Technical Note on behalf of Oxfordshire County Council as Applicant

Didcot Garden Town HIF1 Scheme

Project name Didcot HIF 1	Client Oxfordshire County Council	Subject POETS Request for Regulation 25 Letter Rebuttal	Date 14 December 2023
Prepared by Alex Maddox	Verified by Simon Wild

EIA Regulation 25 Response

Figure 1: Summary plan of locations raised by POETS

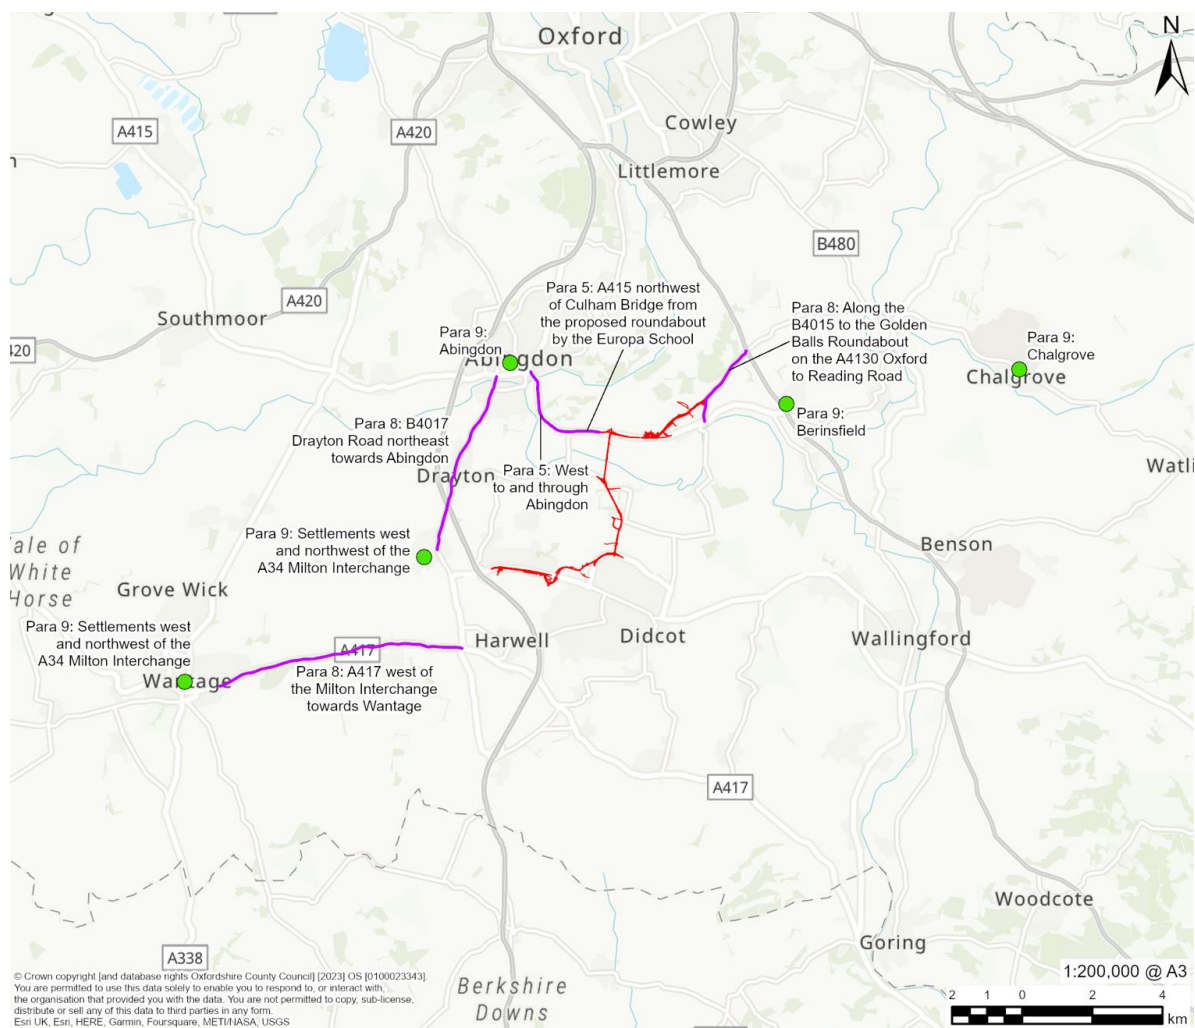
- 2.1.1 Abingdon and the A415 approach to Abingdon (paras. 5 – 7 and 9 of POETS' letter);
- 2.1.2 the B4017 Drayton Road northeast towards Abingdon (para. 8 of POETS' letter);
- 2.1.3 the A417 west of the Milton Interchange towards Wantage (para. 8 of POETS' letter);
- 2.1.4 the B4015 to the Golden Balls Roundabout on the A4130 Oxford to Reading Road (note that it is assumed POETS were referring to A4074 instead of A4130) (para. 8 of POETS' letter);
- 2.1.5 Berinsfield (para. 9 of POETS' letter);
- 2.1.6 Chalgrove (para. 9 of POETS' letter); and
- 2.1.7 settlements west and northwest of the A34 Milton Interchange (para. 9 of POETS' letter).

2.2 For clarity, the Applicant has created Figure 1 which is a summary plan of these locations referred to in the POETS' letter, in relation to the Scheme:

2.3 This Technical Note addresses each of these locations raised in the POETS letter. Due to environmental assessments in the ES being informed by transport modelling, this note first summarises and discusses relevant elements of the transport modelling methodology, and then

discusses the environmental assessments in the ES. In summary, it shows that the scope and extent of the assessments are fully justified and agreed with the LPA.

Figure 6: Route options map (Abingdon)

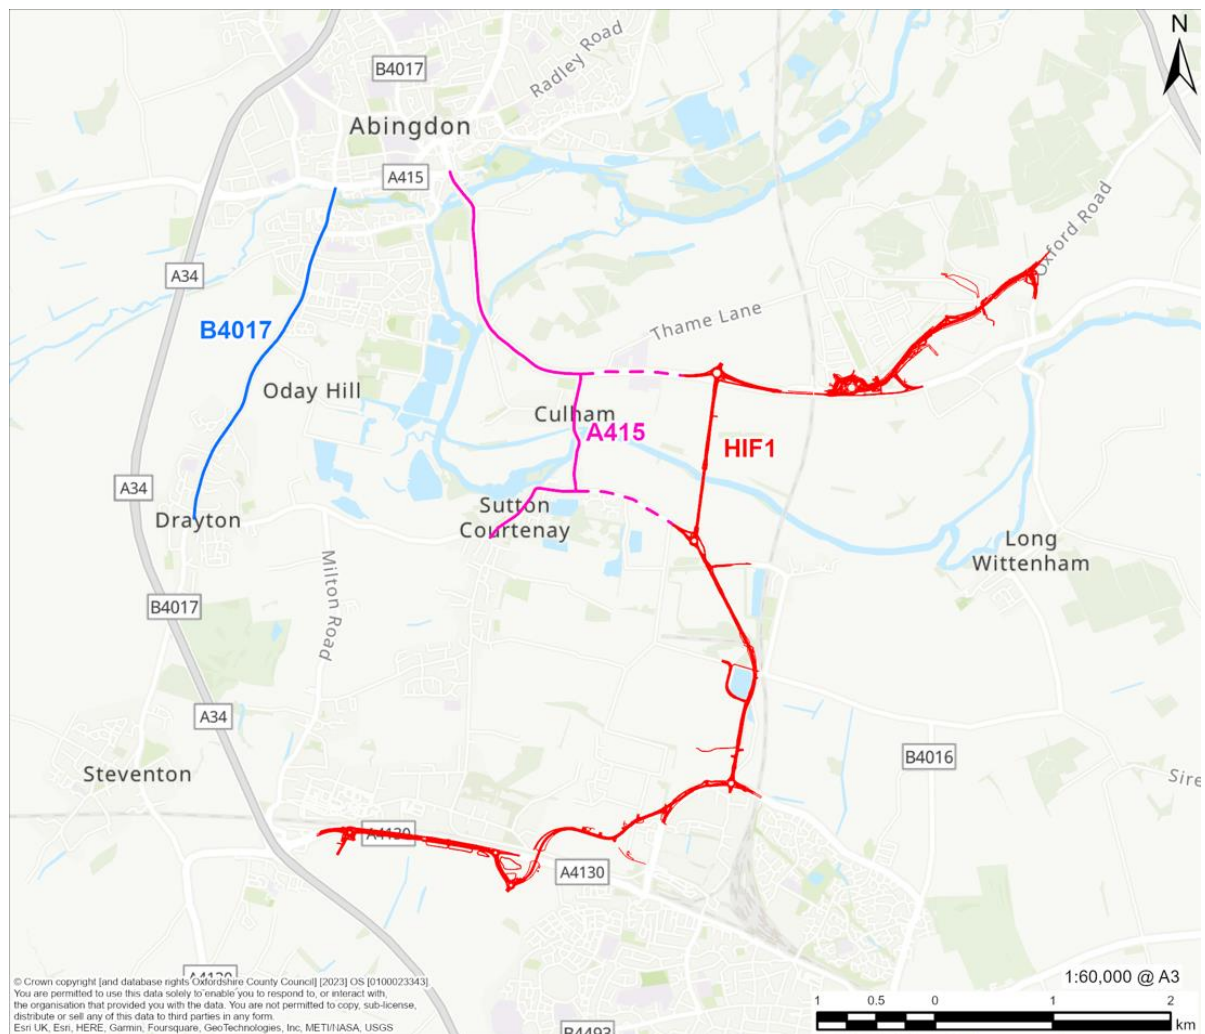
2.17 The Applicant agrees with these statements. The A415 being the only route into / out of Abingdon in this direction, due to the historic highway layout created by the River Thames, means that the Scheme would not influence route choice into / out of Abingdon. The allocated level of growth within the adopted Local Plans of both South Oxfordshire District Council (SODC) and Vale of White Horse District Council (VoWHDC) is the reason for the traffic growth in the area, not the Scheme. If a person lives to the south or southeast of Abingdon (in Didcot or one of the allocated future housing sites, for example) and wishes to drive into Abingdon, their route is along the A415 over Abingdon Bridge, with or without the Scheme, as the alternative routes are significant diversions due to the historic highway layout. See the below plan in Figure 6 for a visual representation of this, whereby the only potential rerouting that the Scheme creates is the dashed magenta lines. The following Table 1 of routes taken depending on a driver’s origin, with and without the Scheme, further explains the situation.

2.18 The same is true for the opposite direction, i.e. a person living in Abingdon and wishing to drive towards the south or southeast.

2.19 Therefore, it is the Applicant's view that the Scheme does not change people's route choice into or out of Abingdon along the A415; if they were going to drive then it would be along this same route regardless of the Scheme. However, the Scheme directly provides significantly improved walking and cycling infrastructure from many destinations to the south (Appleford, Didcot, future development at Valley Park etc) which currently have poor or no dedicated walking and cycling provision. There would

Figure 9: Extract from ES Chapter 10 Figure 10.1: Noise Location Plan

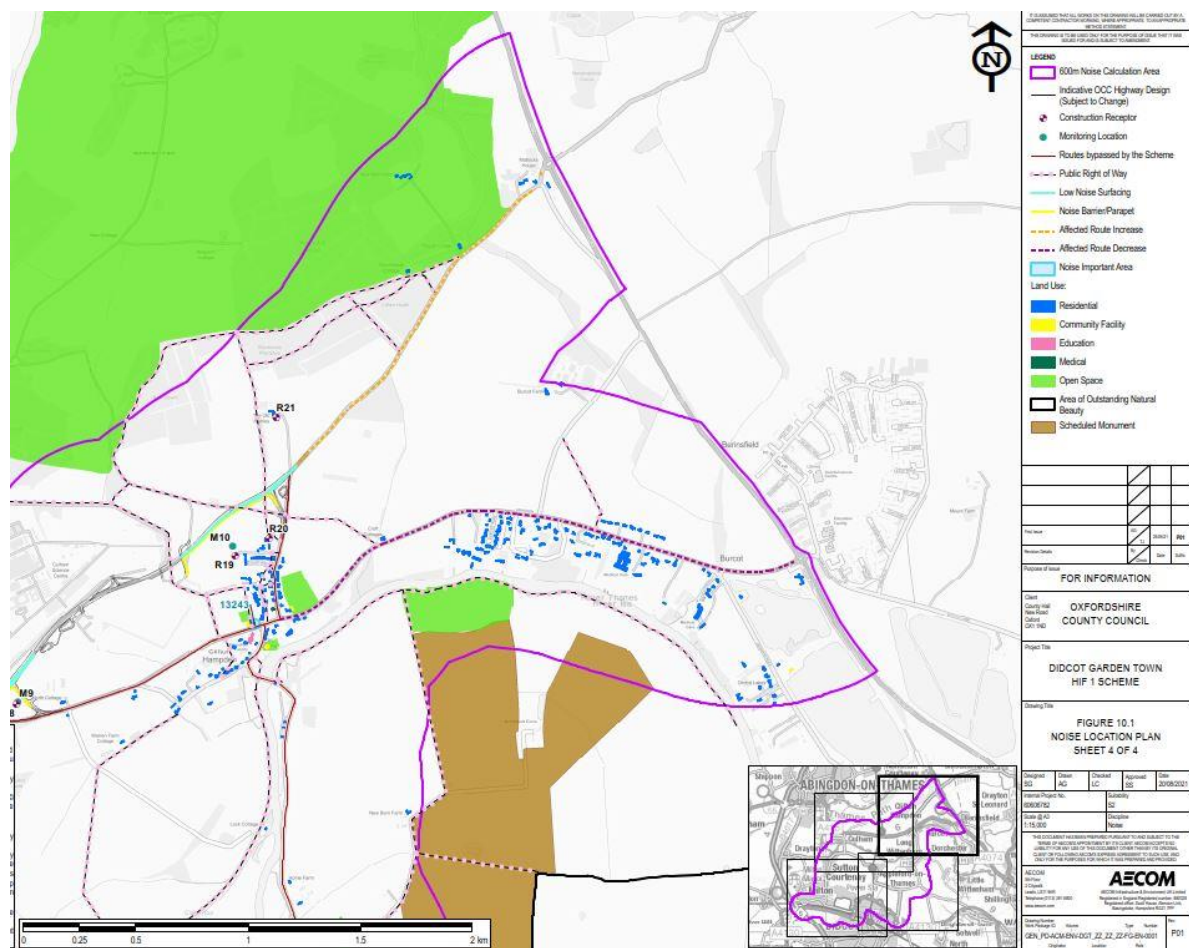
- 2.37 In paragraph 7, POETS state that the ES does not consider the impact of traffic beyond the Scheme boundary. This statement is incorrect.
- 2.38 For example, in defining the study area for the detailed operational noise assessment, the initial study areas comprised the area within 600m of the Scheme and routes bypassed by the Scheme, as required by DMRB LA 111: Noise and Vibration². Further, all links in the Paramics traffic model (as shown in Figure 4) were considered as part of the assessment, initially using a spreadsheet calculation looking at the 'basic noise level' (BNL) to identify 'affected routes' (with at least a minor change in BNL). Two 'affected routes' were identified which extend outside of the initial 600m area, namely the A415 and B4015 to Golden Balls (A4074) east of the Scheme. The detailed assessment study area was therefore extended to include these locations: see Figure 9 for an extract from ES Chapter 10 Figure 10.1: Noise Location Plan below. When considering all links in the traffic model, no other 'affected routes' were identified. See Section 10.6 in Chapter 10: Noise and Vibration of the ES for further details. Whilst settlements such as Abingdon, Nuneham Courtenay or settlements east of the Golden Balls junction have not been subject to a detailed noise and vibration assessment, these settlements were considered when defining the study area and it is considered that these areas would not experience significant adverse effects given the negligible change in basic noise level along links located towards these areas.

Figure 11: Illustrative plan of A4130 Capacity Improvements (this plan is for indicative purposes only)

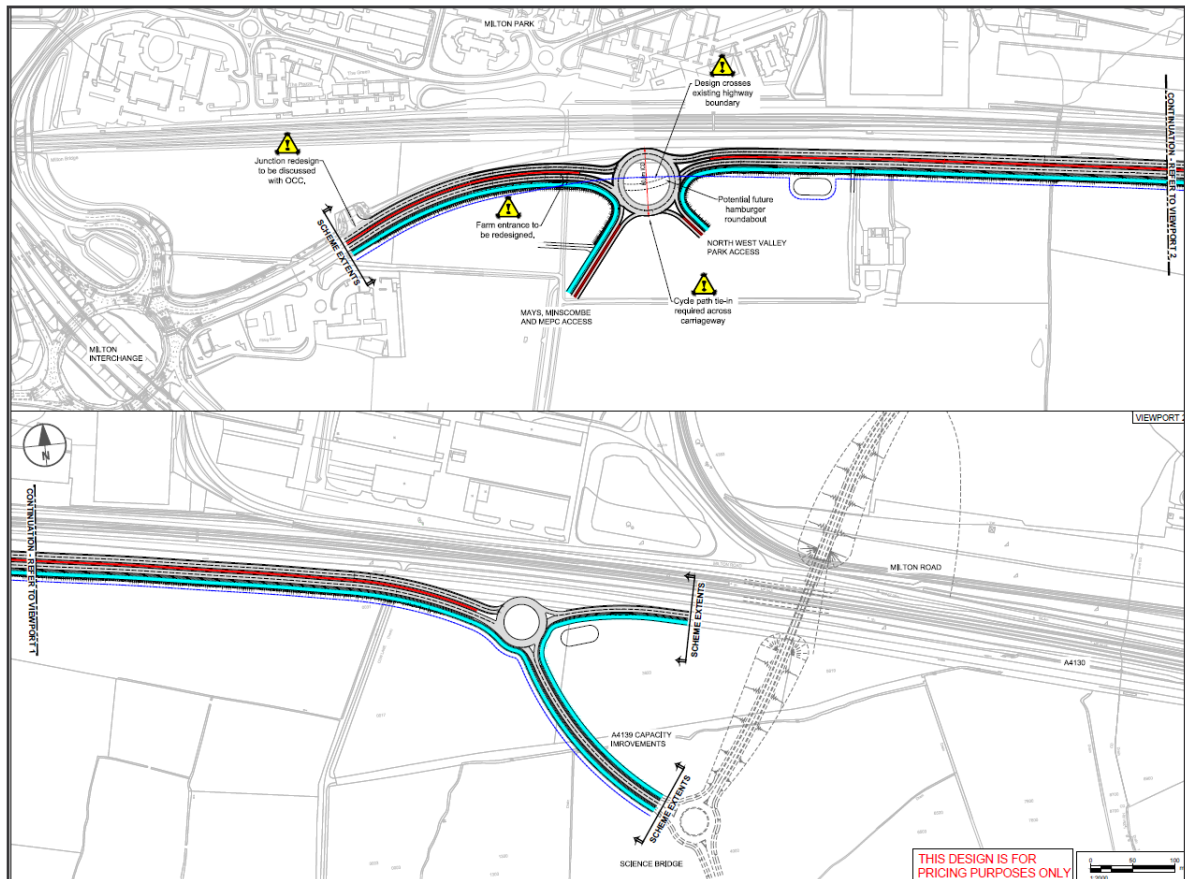
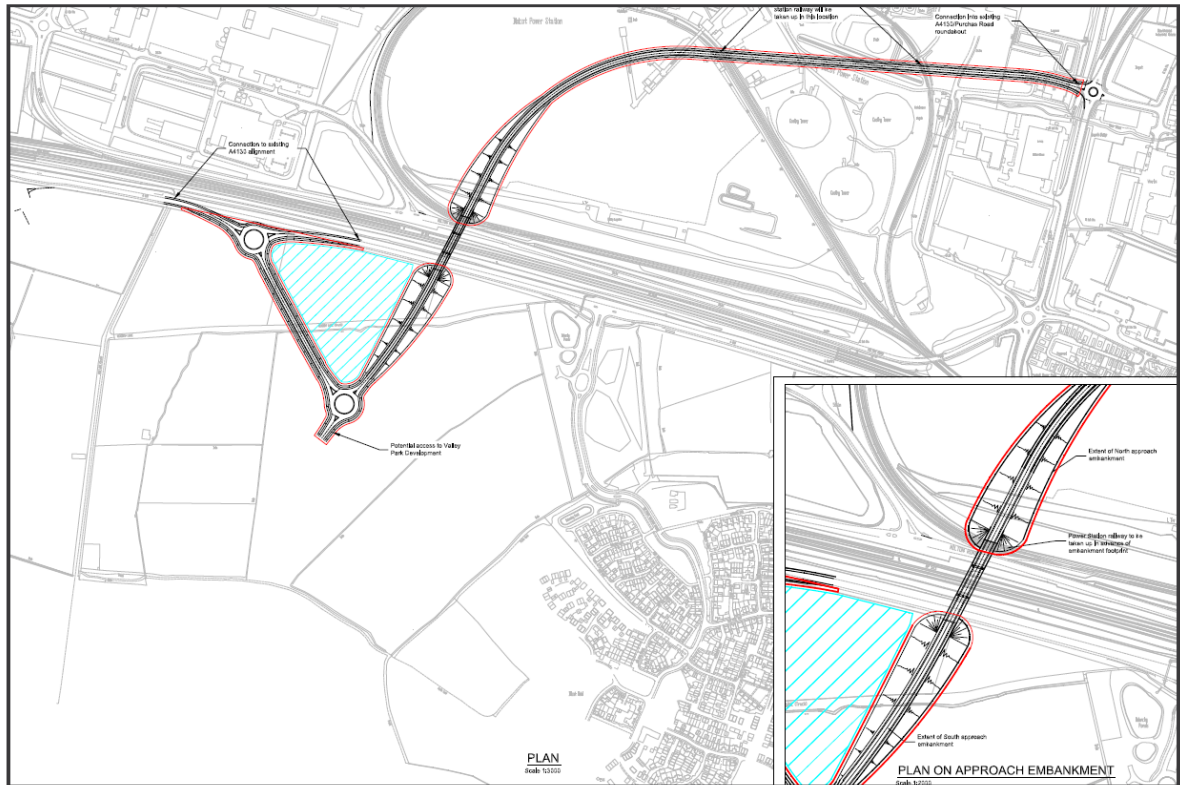
- 4.1 At paragraph 19 of their letter POETS suggest that cycling/walking facilities were belatedly added in to appease people raising environmental concerns. That is incorrect. The design of the HIF 1 Scheme has always included walking and cycling facilities along its entire length. The 2018 public consultation, held when the Scheme was at a very early stage of design, specifically stated for each of the four scheme element proposals *"It will include pedestrian & cycle infrastructure along its length"*. Additionally, the consultation showed illustrative plans of the early scheme designs that show the walking and cycling provisions alongside, provided below for ease of reference (note that the River Crossing plan was at a zoomed-out scale as it was showing multiple alignment options, so the walking and cycling provisions are not visible, and therefore it has not been replicated here):

“the belated inclusion of cycling and walking in this option was, in the view of POETS, no more than a sop to environmental concerns, in order to give it a cloak of respectability and responsibility so that the Scheme could be presented as a new approach to transport planning. But, as a matter of fact and degree, this inclusion of some elements of sustainable transport was nothing more than a fig leaf to try to deflect criticism from environmental groups.”

Figure 3.25: Culham Crossing Queue Length

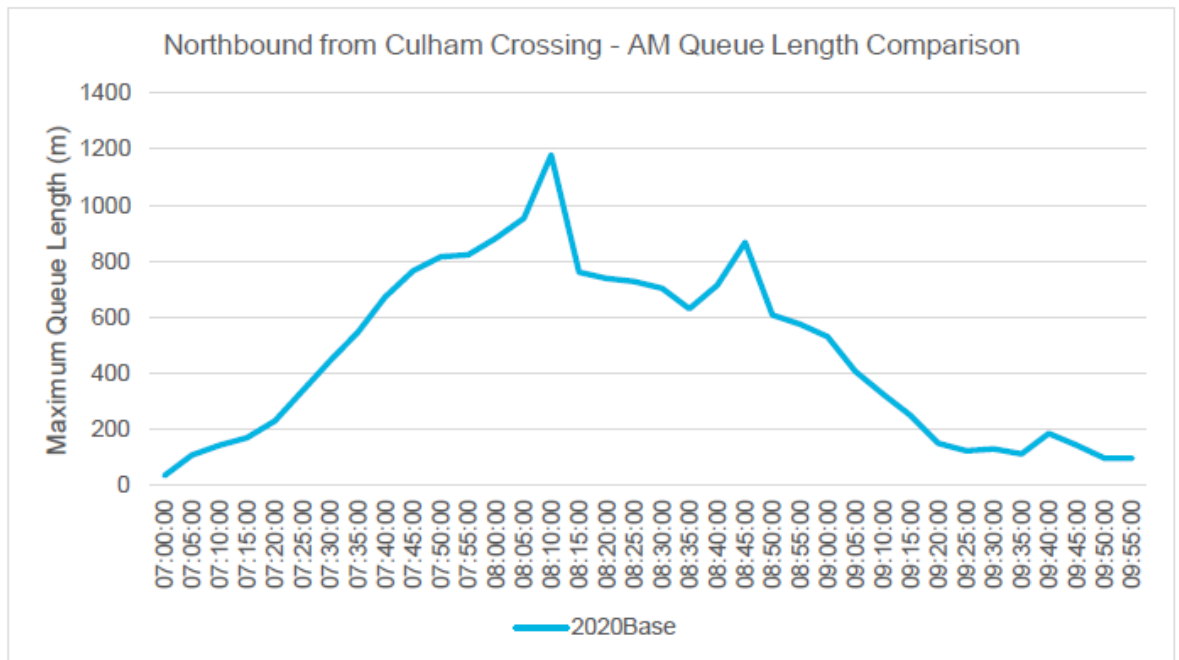
9.2.9.3. The results in table 3.12 of the TA, indicate that the network is operating over capacity in both the AM and PM peaks, with PRCs of -22% and -14% respectively. In the AM peak long northbound queues are shown to occur at the Abingdon Road/Tollgate Road junction and at the Culham Bridges. In the PM peak queues are indicated on Abingdon Road (E) arm of the Tollgate Road junction and at the Culham Bridges in both directions.

9.2.9.4. These junctions are complex to model due to the interaction of queuing back between them, particularly the uncontrolled priority junction at the south. For example, the Culham Bridges northbound AM predicted queue is 51 PCUs which would queue back to/through Appleford Road / Abingdon Road priority junction, however LinSig does not take account of this as shown by the predicted queue of 0 PCU on the Appleford Road (W) arm. There is a known queue on this arm in the AM peak. To further interrogate this, queue lengths have been extracted from the Paramics model to compare how the junction operates across different model platforms. Paramics takes account of the whole modelled network including interaction between adjacent junctions. In Paramics, a vehicle is determined to be in a queue when the speed drops below 4.47 mph and the distance to the vehicle in front is less than 10 metres.

9.2.9.5. Figure 3.25 from the TA, (replicated above) shows that the Paramics model indicates queue in the AM peak extending from the northbound signals before the bridge, back for 500m to 1180m across the 0800-0900 AM peak. This is known locally, with queues often extending past the George & Dragon Public House. The queueing in this area is the subject of OCC's objections to applications of single dwellings on grounds of highway safety, convenience and sustainability. These objections have led to Local Planning Authority (LPA) refusals which have been upheld at appeal by the Planning Inspectorate.
